Staff Presentation to the
Portland Design Commission

Type III Design Review + Central City Master Plan Review
LU 15-281248

Broadway Tower

March 24, 2016

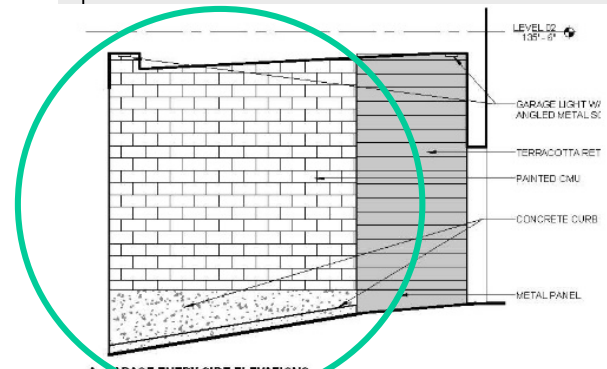
B. Any original materials, or materials of good quality, that can be salvaged from the existing building, shall be salvaged. (A3, A6, A7, C3)

A. GARAGE ENTRY SIDE ELEVATIONS

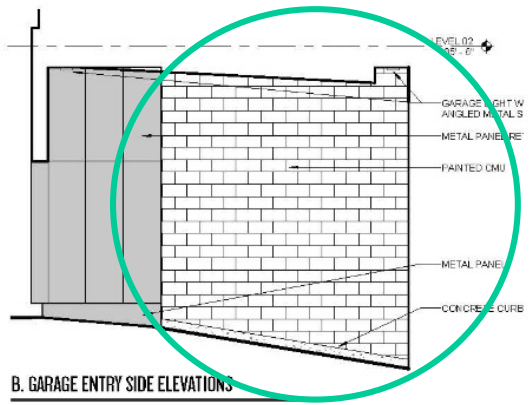
C. The interior side walls of the garage recess shall be clad with either terra cotta or metal and the metal panel at the face of the garage recess shall be clad with terra cotta.
